**TOWN OF BAY HARBOR ISLANDS
PLANNING AND ZONING BOARD**

October 19, 2016

FINAL AGENDA

**TOWN OF BAY HARBOR ISLANDS
COMMUNITY DEVELOPMENT
MEMORANDUM**

SOUTH ELEVATION
SCALE: 1/8" = 1'-0"

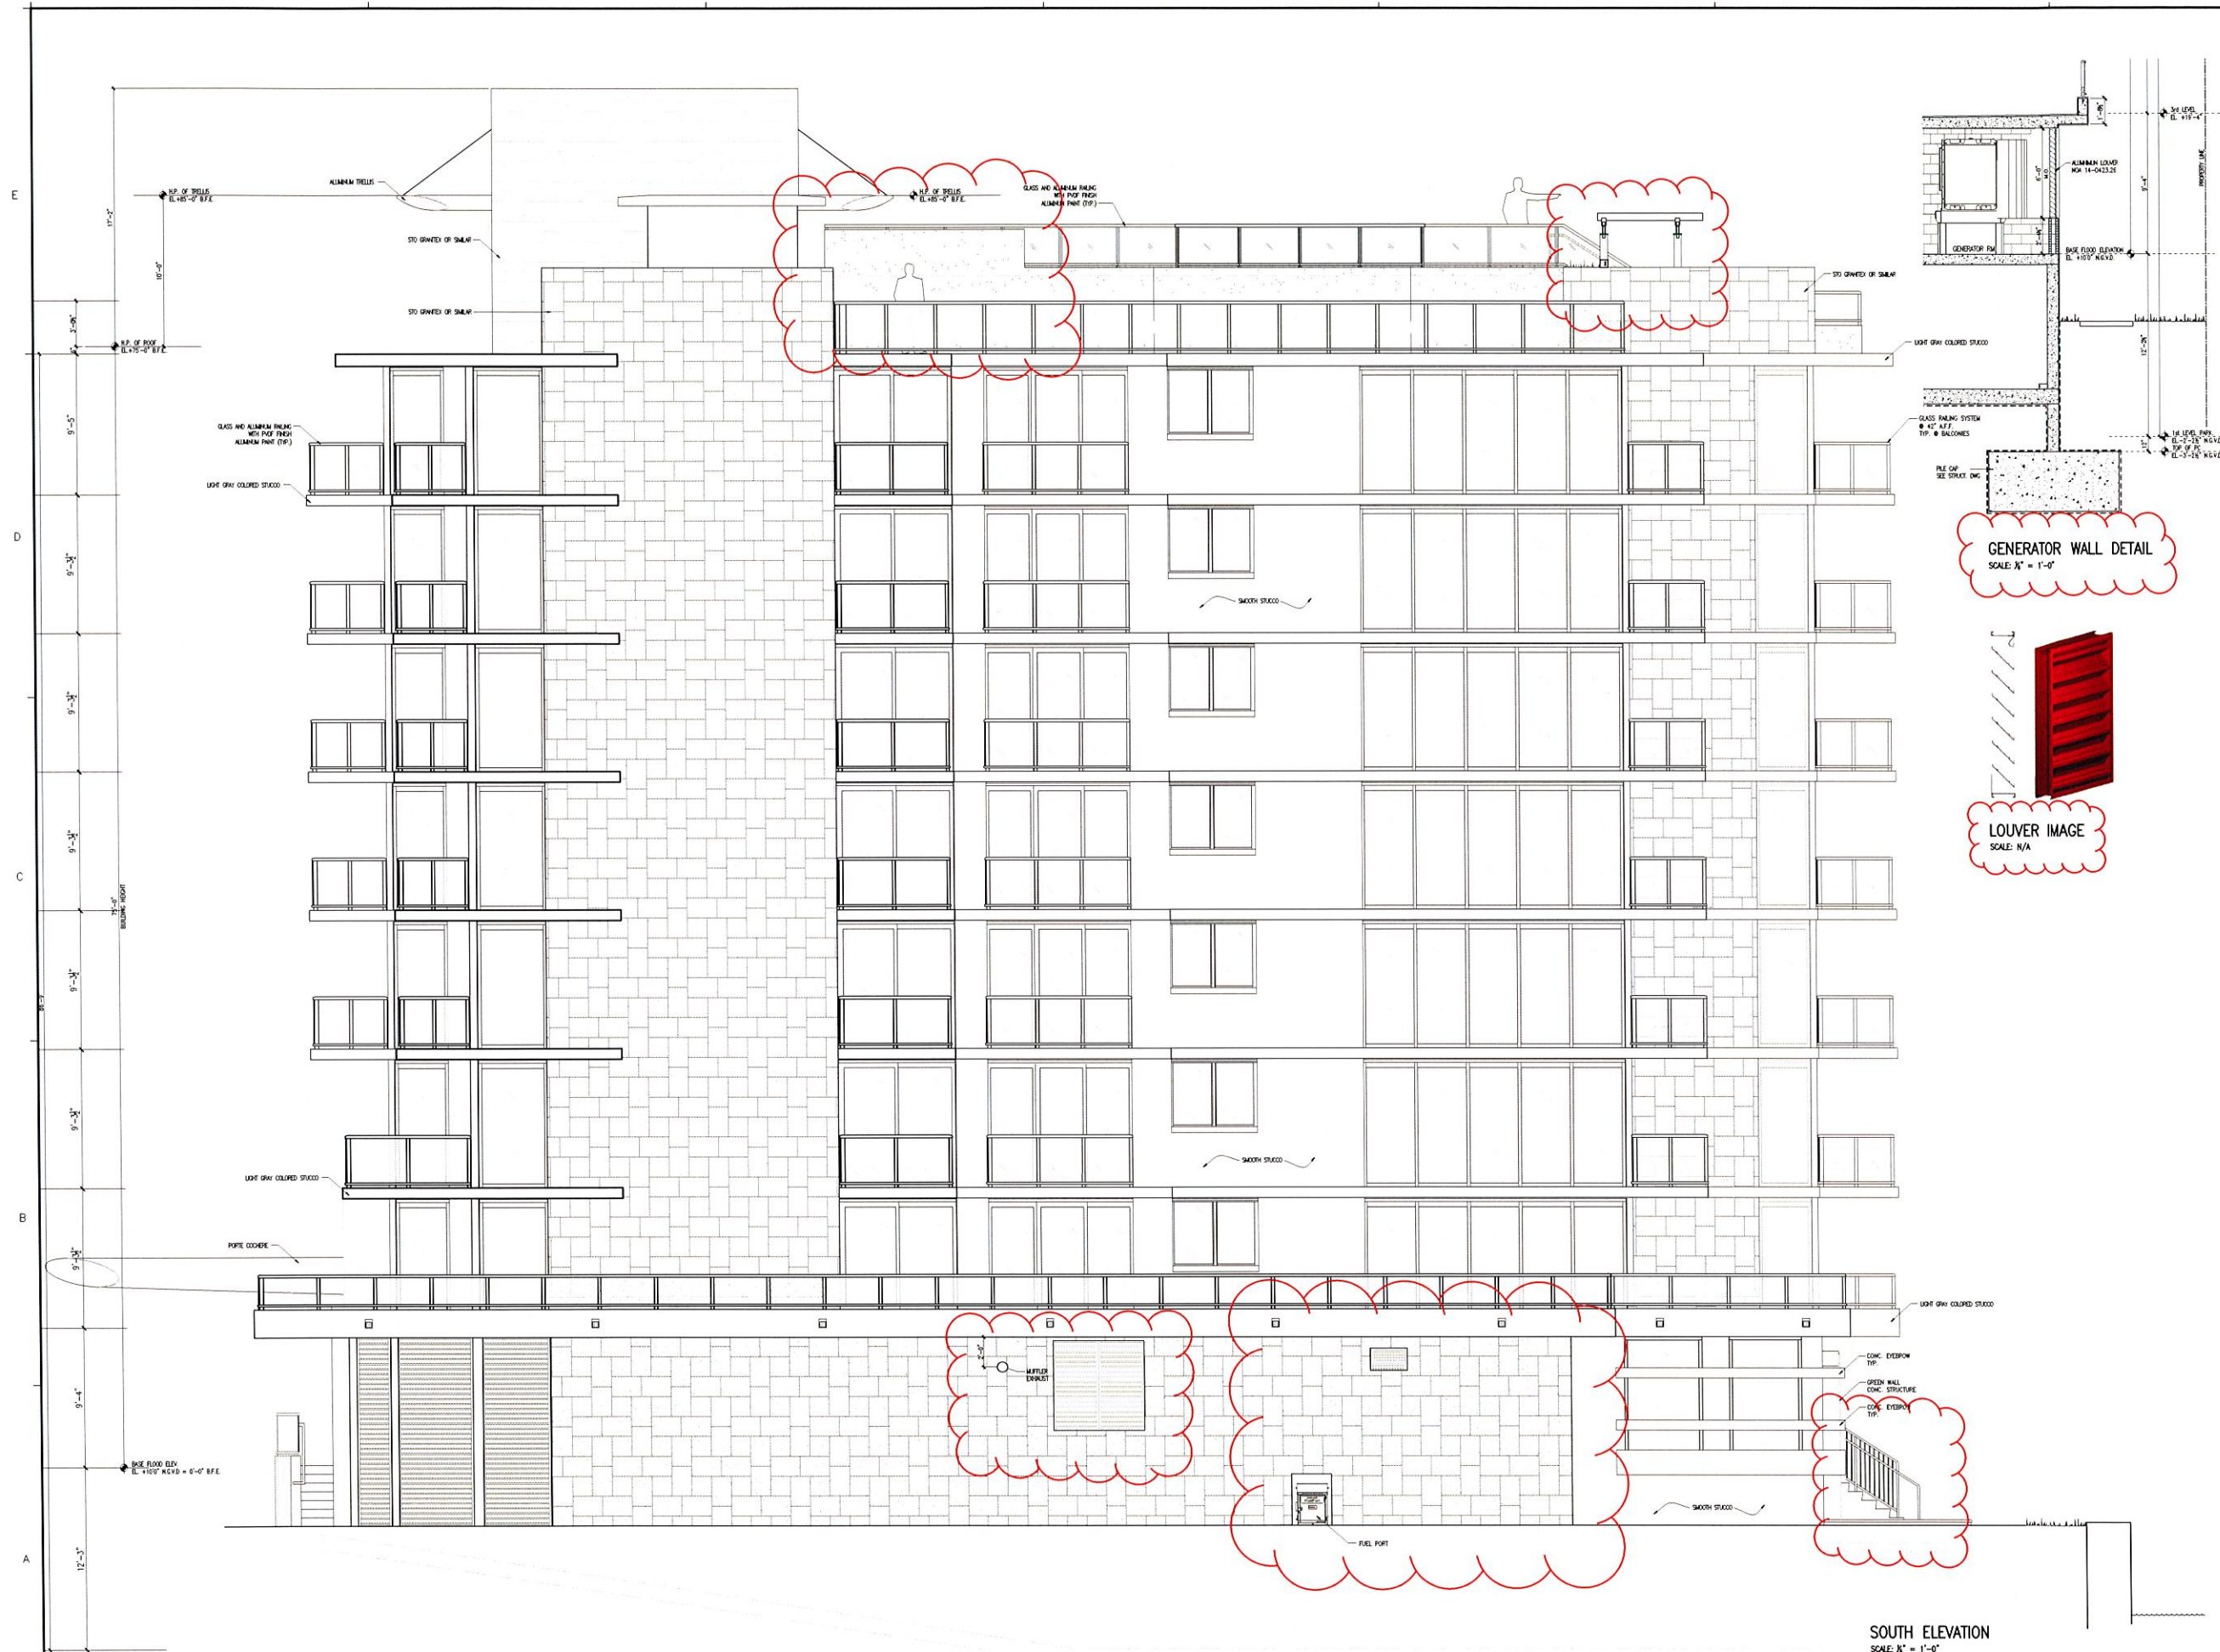
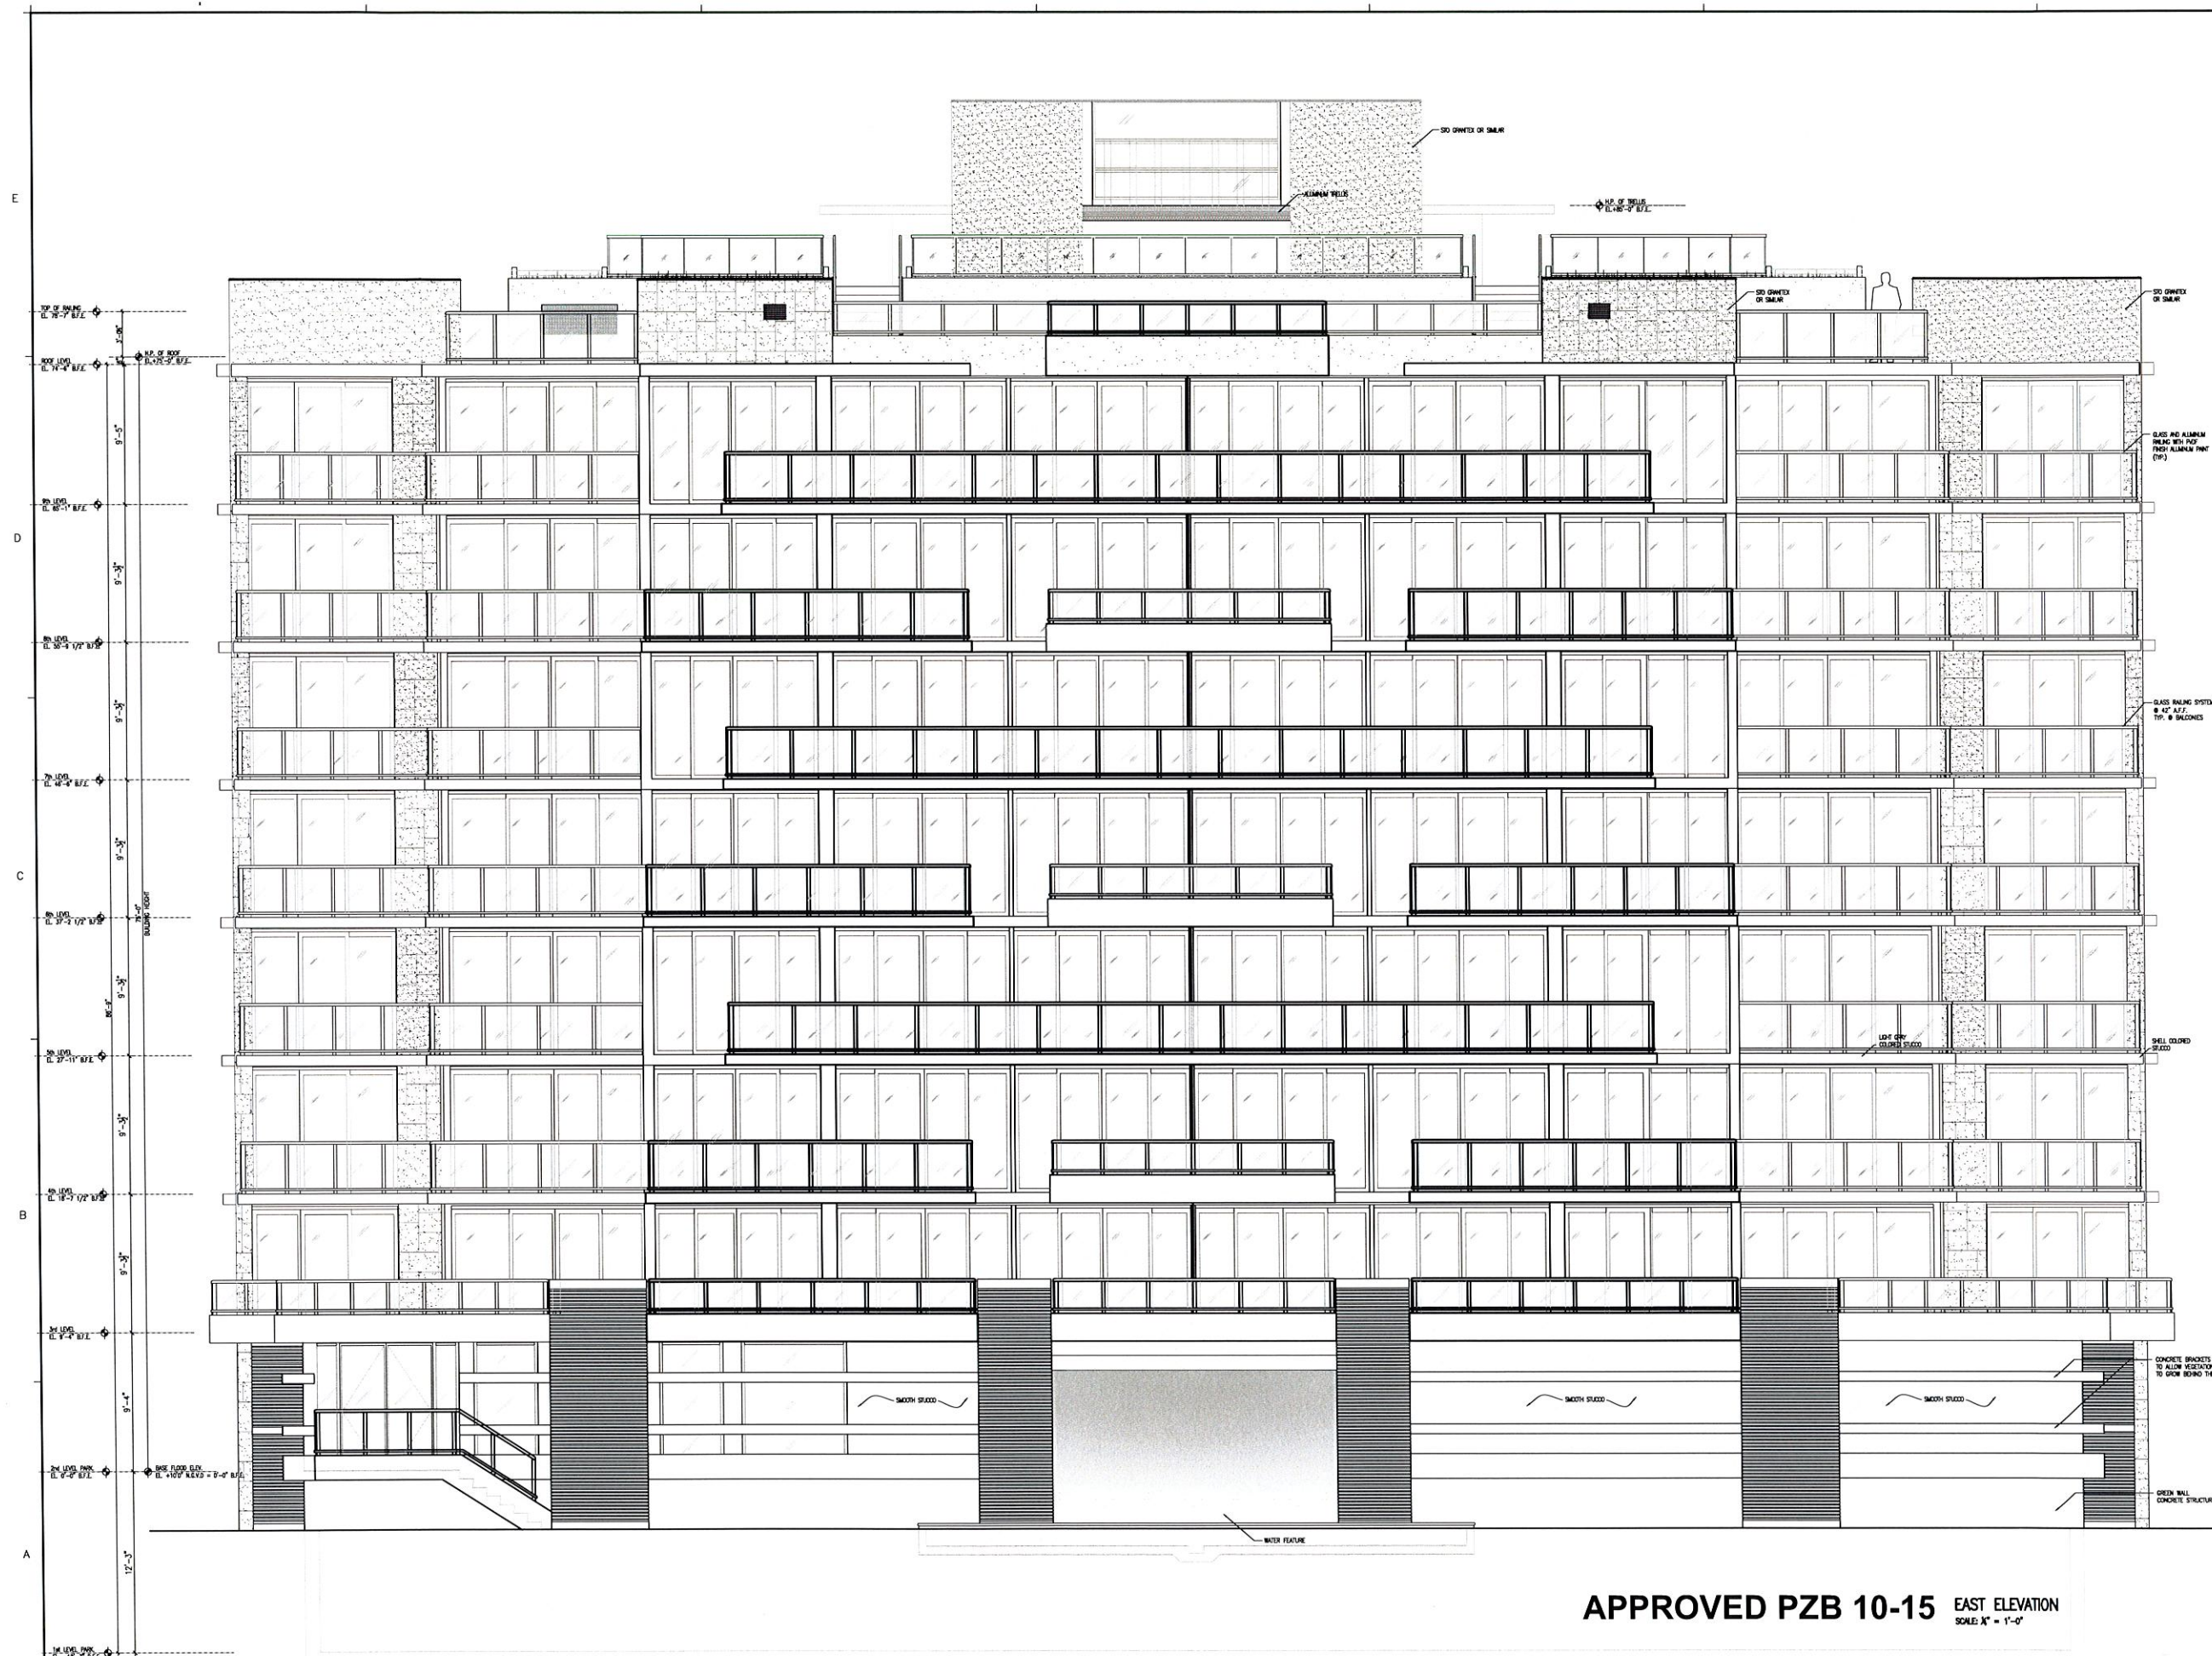
- 3) The building elevations have changed slightly from the PZB approved plans. The design at the Roof Level has changed slightly. The most noticeable changes are to the South Elevation (generator screening now shown at the garage levels) and to the East Elevation (reduction of windows on each side of the façade). The applicant is proposing to reduce the number / design of the windows due to the location (large windows in bathrooms / closets). **PZB approval is being requested for the new revised design.**
